Characteristics

Comparison table of applicable max cylinder tube bore of standard type (conventional model) and large flow type

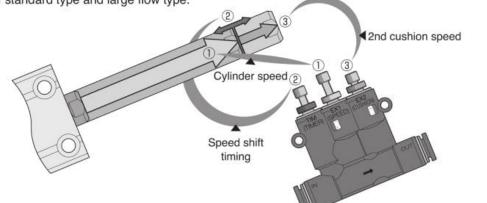
Classified the three lock nuts by color according to the roles. It enables reliable operation.
